Recall Bulletin

SUBJECT: Shift Lever Indicator May Not Display Correct Gear

MODELS: 2008-2010 Chevrolet Malibu
2008-2010 Pontiac G6
2007-2010 Saturn AURA
Equipped with 4-Speed Automatic Transmission (ME7/MN5)

The Service Procedure and Warranty Transaction Information sections in this bulletin have been revised to include an inspection of the transmission shift cables. Please discard all copies of bulletin 12106.

3256032

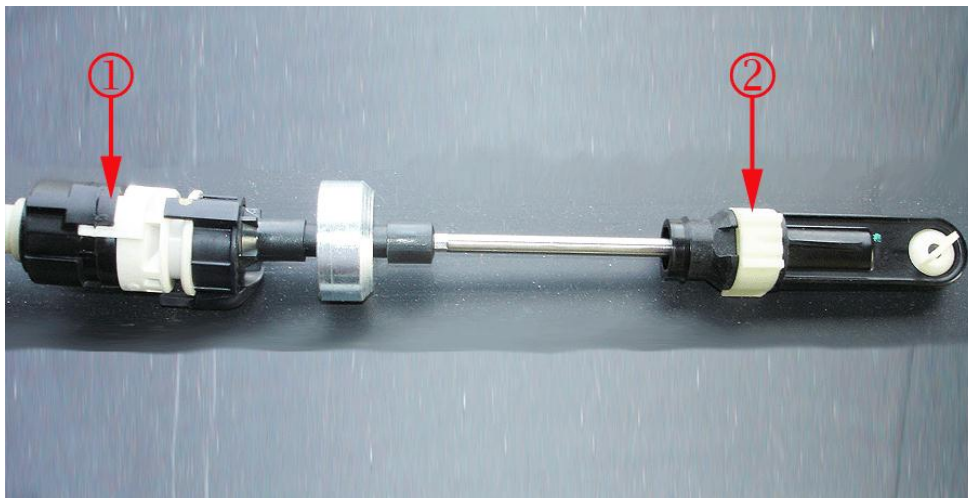
Note: Perform the service repair procedure in this bulletin on second design transmission shift cables only. First design transmission shift cables do NOT require a repair. Refer to the illustration to view a first design shift cable. Refer to *Transmission Shift Cable Kit Installation Procedure* in this bulletin to view the second design transmission shift cable.

2269489

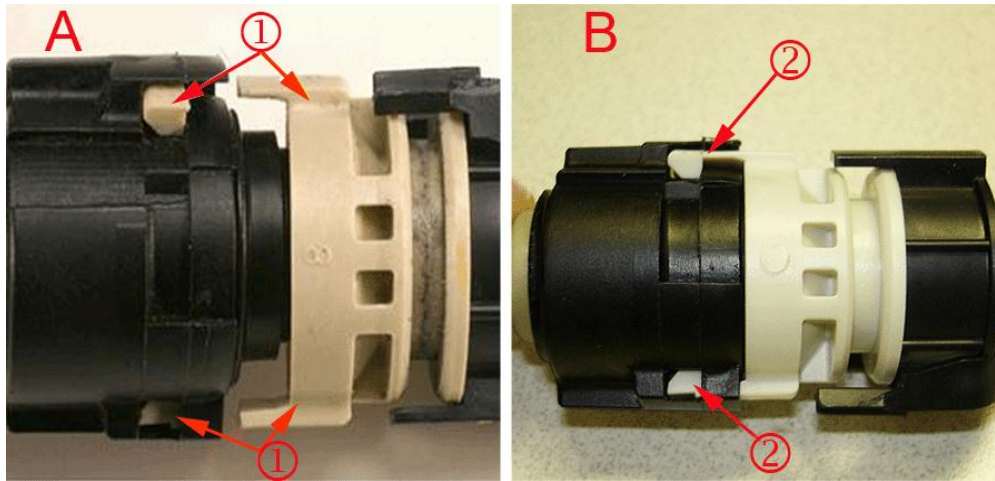
- (1) Shift Cable Locking Tabs
- (2) Shift Cable Adjuster Locking Clip

1. Open the hood and locate the transmission shift cable.
2. Determine if the transmission shift cable locking tabs are fractured and separated.
